**Request for Additional Information No. 505 (5902,5735,5869,5754,5803,5950,5744),
Revision 0**

U. S. EPR Standard Design Certification

Docket No. 52-020

Application Section: FSAR Chapter 7

Figure 4-2—Block Diagram with Diversity Attributes

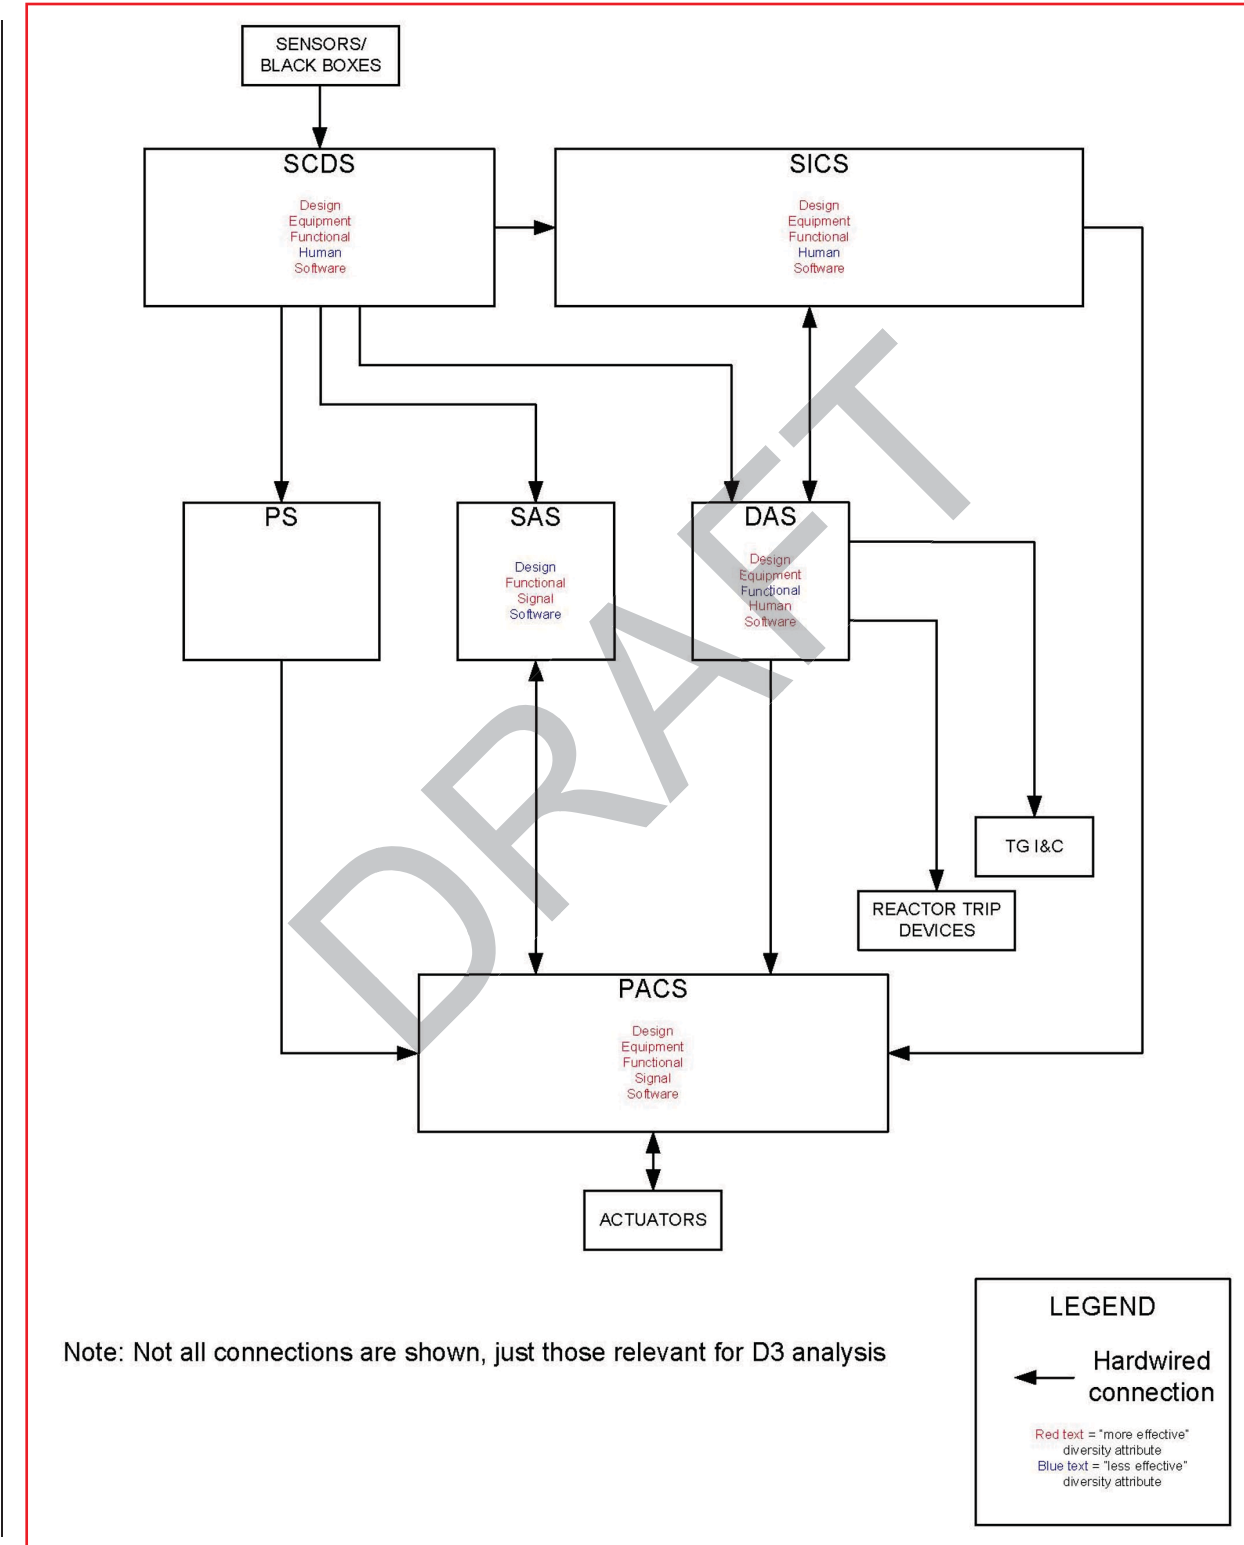
- b. Table 2-1 of Technical Report ANP-10304 states that the SICS indicators can include programmable electronic I&C technology, which, according to Tier 2, Section 7.1, Interim Revision 3 mark-ups, can be TXS microprocessor-based. By contrast, Section 4.2 of Technical Report ANP-10304, SICS design diversity, states that the indications provided in SICS are performed by hardwired, analog components. The information provided for the design basis items, taken alone and in combination, should have one and only one interpretation. The staff request the applicant to provide clear design descriptions about the type of SICS indicators that are credited in the Technical Report ANP-10304.

- a) Technical Report ANP-10304 will be revised to clarify the commitment that different design organizations will be responsible for the design of the two systems.
- b) Section 4.2 in Technical Report ANP-10304 will be revised as shown in the attached markups.
- c) U.S. EPR FSAR Tier 2, Section 7.1 defines programmable electronic instrumentation and control (I&C) technology as: "I&C technology that is based on solid state components whose function is programmed via software." While this can include microprocessors, the safety information and control system (SICS) indicators credited in the defense-in-depth analysis do not use Teleperm XS (TXS) microprocessor-based programmable electronics.
- d) Section 4.2 in Technical Report ANP-10304 will be revised as shown in the attached markups.

RAI 505,
Q. 07.08-43
